REMARKS

This amendment is in response to the Official Action dated December 17, 2004. The drawings, specification and Claims 1-5 have been amended. Claims 1-5 remain in the application with Claim 1 being the only independent claim. Favorable reconsideration, in view of the above amendments and accompanying remarks, is respectfully requested.

AMENDMENTS TO THE DRAWINGS

ANNOTATED MARKED-UP  
DRAWINGS

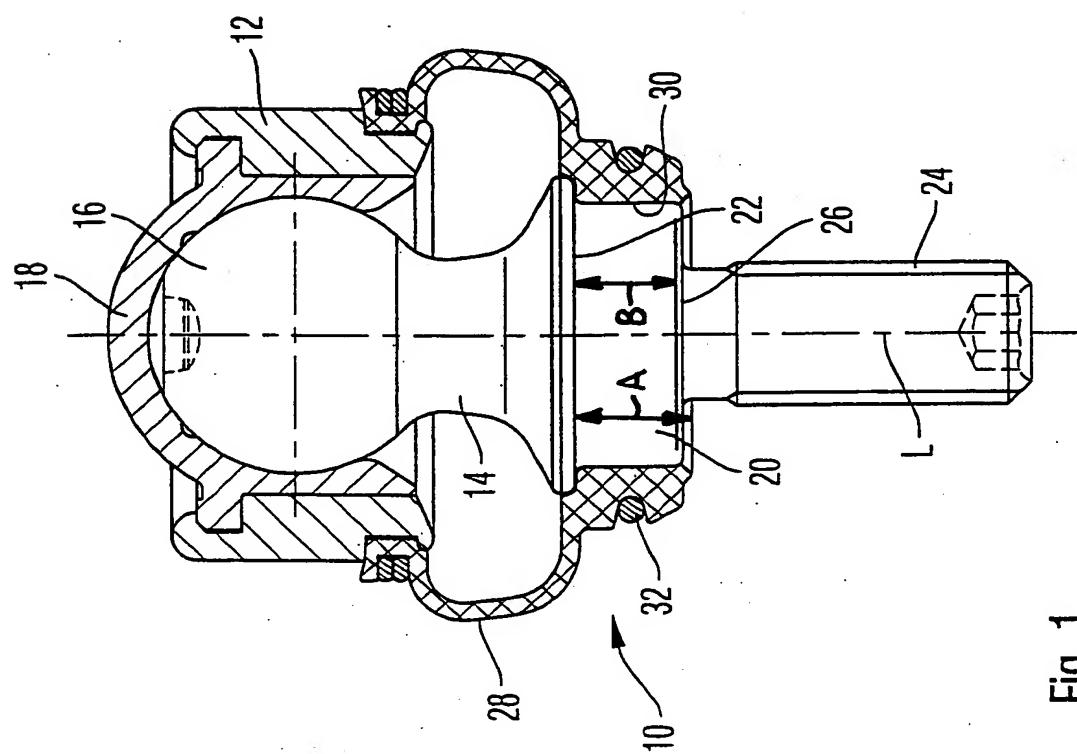
Please amend drawing Fig. 1 by adding the dimensions identified by reference characters A and B as shown in red on the attached drawings. Attached herewith are “Replacement Sheets” of Sheet 1 of 1, Figs. 1 and 2, and “Annotated Marked-Up Drawings” of Sheet 1 of 1, Figs. 1 and 2. Formal drawings will be submitted upon approval of these changes and issuance of a Notice of Allowance.
